**REGULAR MEETING OF THE UNITED LAGUNA HILLS MUTUAL
ARCHITECTURAL CONTROL AND STANDARDS COMMITTEE**

**Wednesday, January 17, 2018 – 9:30 a.m.
Laguna Woods Village Community Center Sycamore Room
24351 El Toro Road**

DATE: January 17, 2018
FOR: Architectural Controls and Standards Committee
SUBJECT: Conversion of Architectural File Drawings to CAD

DATE: January 17, 2018
FOR: Architectural Control and Standards Committee
SUBJECT: Variance Request: Mr. Ohsoon Chun of 105-C (San Sebastian, 7)
Extend Living Room onto Existing Patio

NEW WORK FLOOR PLAN

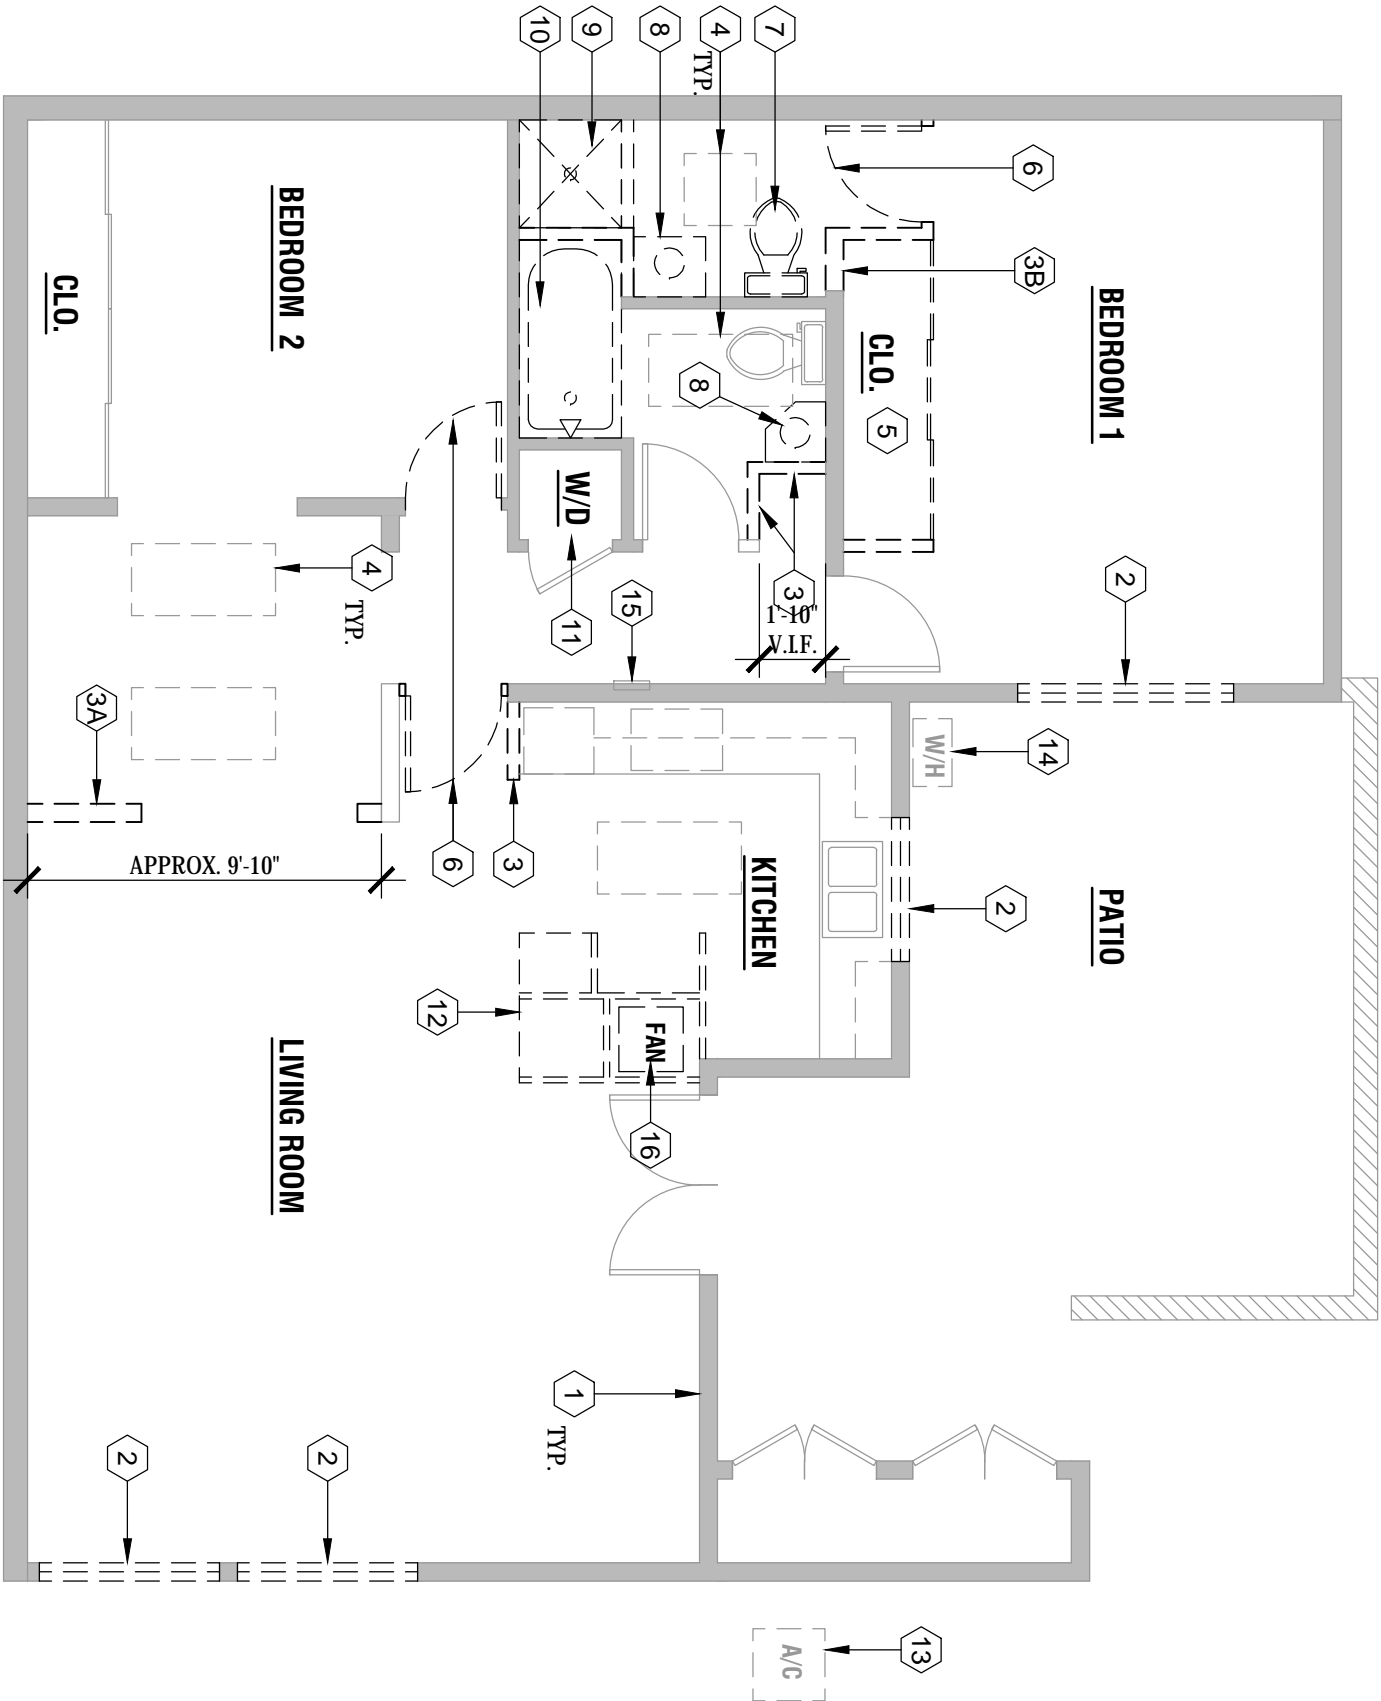
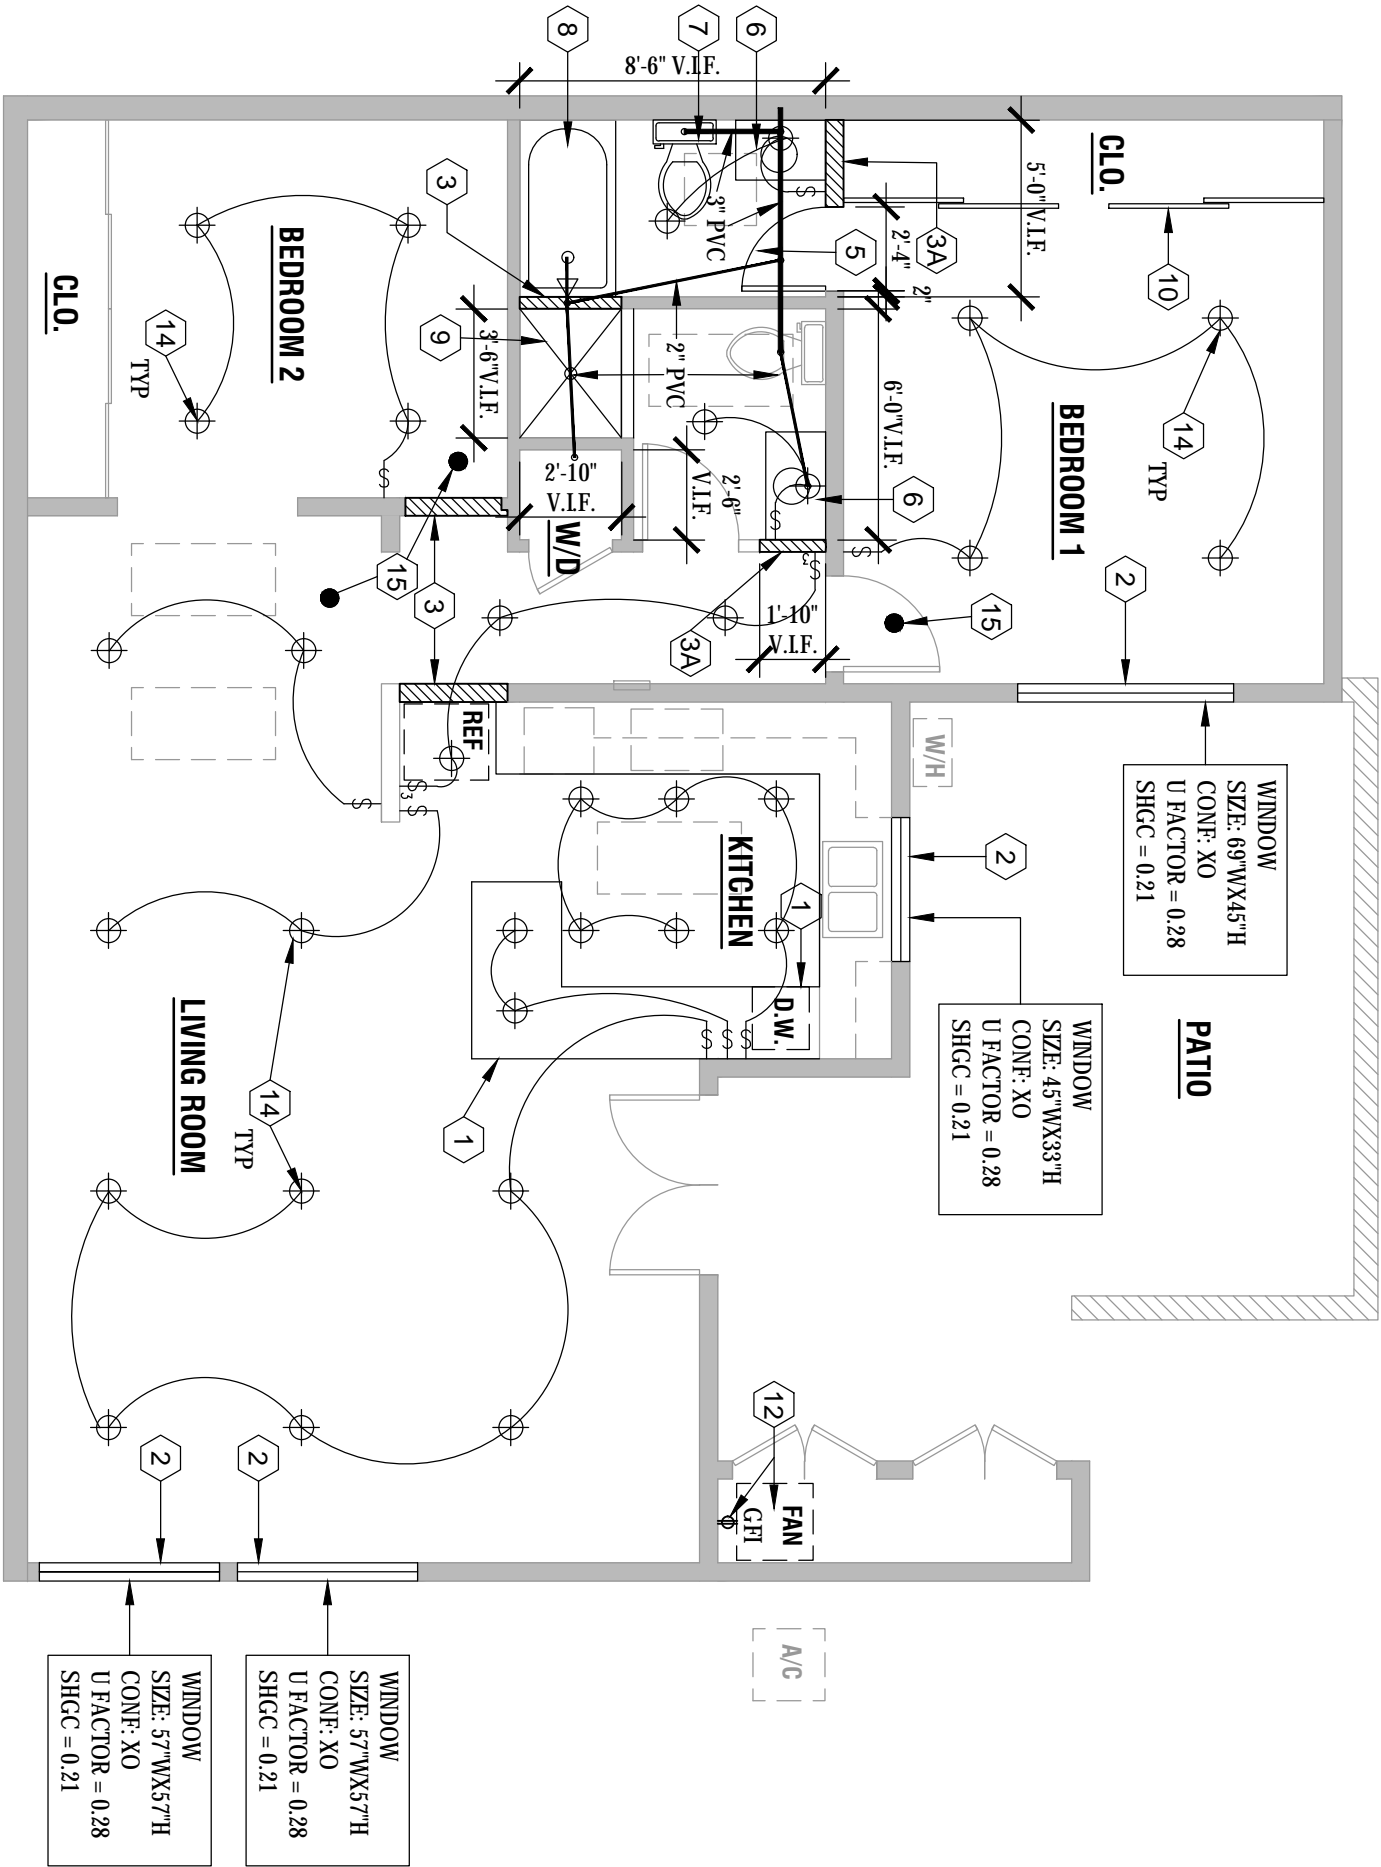
Mr. Cho is also proposing to remove the existing closet in the master bedroom, and add a new infill wall measuring two feet, eight inches wide as part of a bathroom remodel (Mutual Consent via Bathroom Split Mutual Standard). The new closet will be eight feet tall and located on the adjacent wall (see Attachment 1) and will measure twelve feet wide by two feet deep.
